Amendments to the Drawings:

ANNOTATED SHEET
TO SHOW
CHANGES MADE

Title: IMPACT ABSORBING
STRUCTURE FOR VEHICLE
STEERING SYSTEMS
Inventor(s): Mitsuji YAMAMURA
Appl. No.: 10/733,249

FIG.4

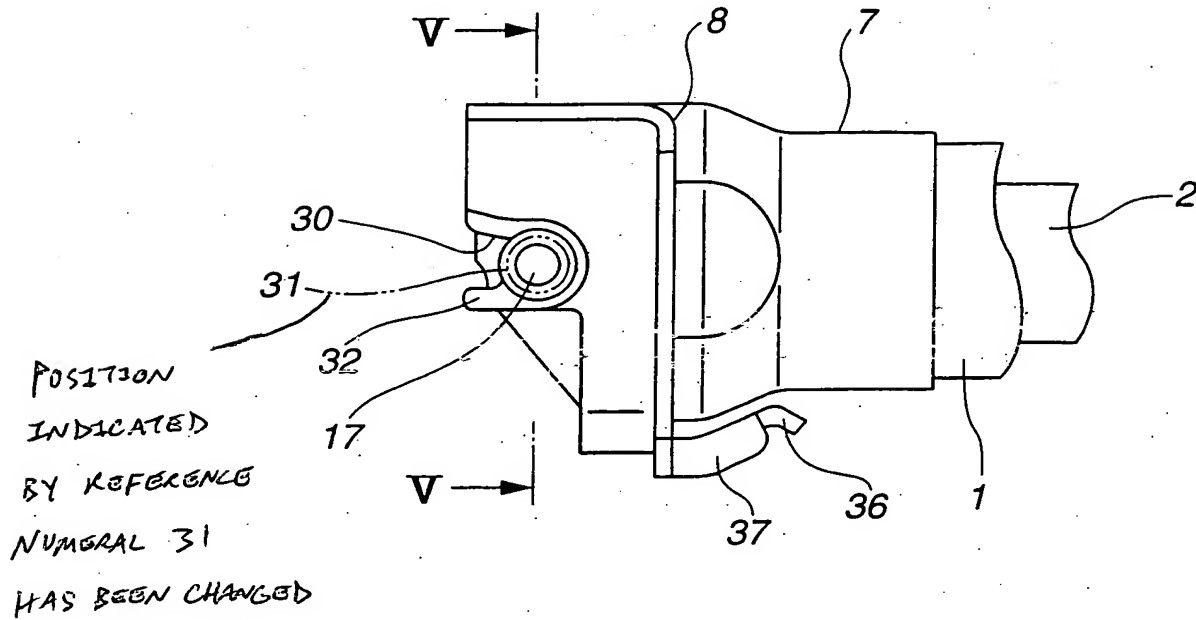
The specific changes which have been made to Figure 4 is to change the position indicated by reference numeral 31.

The drawings are objected to for not showing every feature of claim 9 and because reference characters “17” and “31” have both been used to designate the pivot in Figure 4. The drawings have been amended to overcome these objections. Withdrawal of these objections is respectfully requested.

The drawing sheet attached in connection with the above-identified application containing Figures 4 and 5 is being presented as a new formal drawing sheet to be substituted for the previously submitted drawing sheet. The drawing Figure 4 has been amended. Appended to this amendment is an annotated copy of the previous drawing sheet which has been marked to show changes presented in the replacement sheet of the drawing.
